California Department of Transportation

RE: LA County General Hospital Campus
Community Plan - Subsequent EIR
SCH # 2014051061
Vic. LA-5/PM 18.78, LA-10/PM 19.07
GTS # LA-2025-05076-Subsequent EIR

Aerial Photo #1, I-5 SB to Mission Rd.

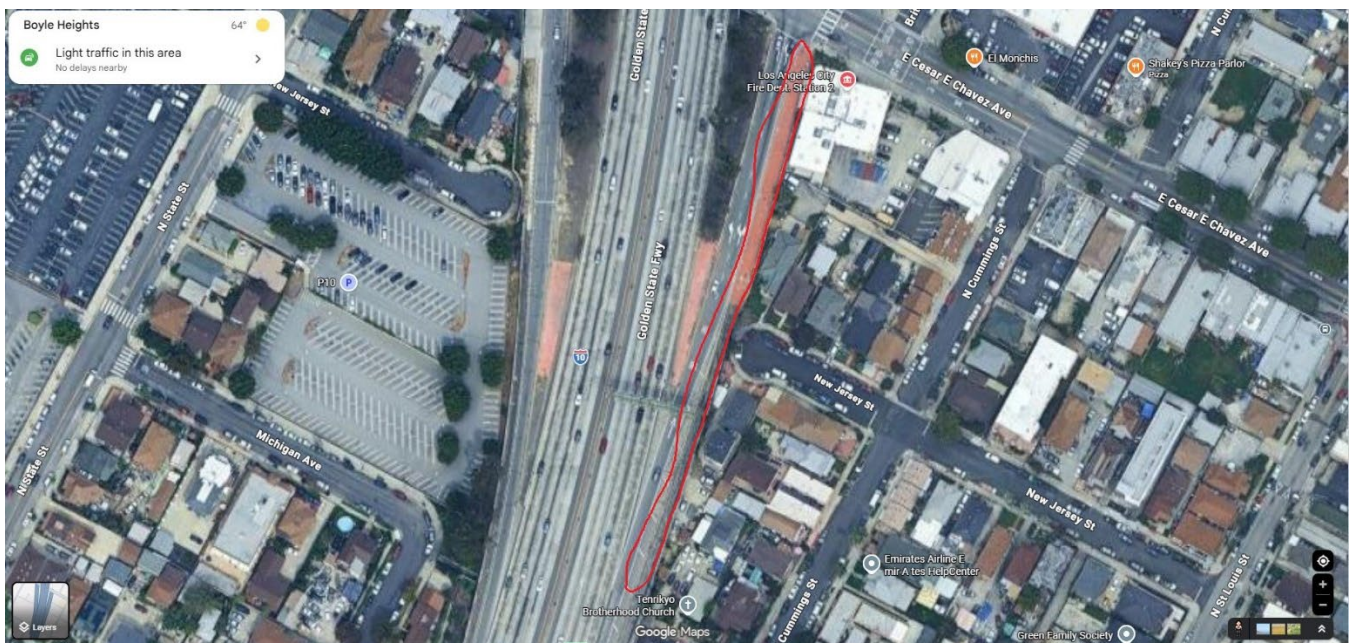
- **TRA-3a:** Re-stripe the I-5 southbound off-ramp to Mission Road from a left turn lane, shared through-left lane, and right lane to two left turn lanes and one shared through-right lane. Optimize signal timing along Mission Road, including cycle length, offset, and phase splits. Apply Caltrans' Intersection Safety Operational Assessment Process (ISOAP) methodology as appropriate for intersection improvements.

While mitigation measures TRA-3a through TRA-3d aim to optimize intersection operations, significant traffic impacts remain due to excessive queue lengths and limited storage at freeway off-ramps. Caltrans recommends the County evaluate increasing storage length, as **Aerial Photo #1 to #4** indicate sufficient right-of-way may exist. A collaborative review with Caltrans is advised to confirm feasibility. Consistent with CEQA Guidelines §§ 15091 and 15126.4, Public Resources Code § 21002, and § 15092(b)(2), a project cannot be approved if feasible mitigation measures are available that would substantially reduce or avoid significant impacts.
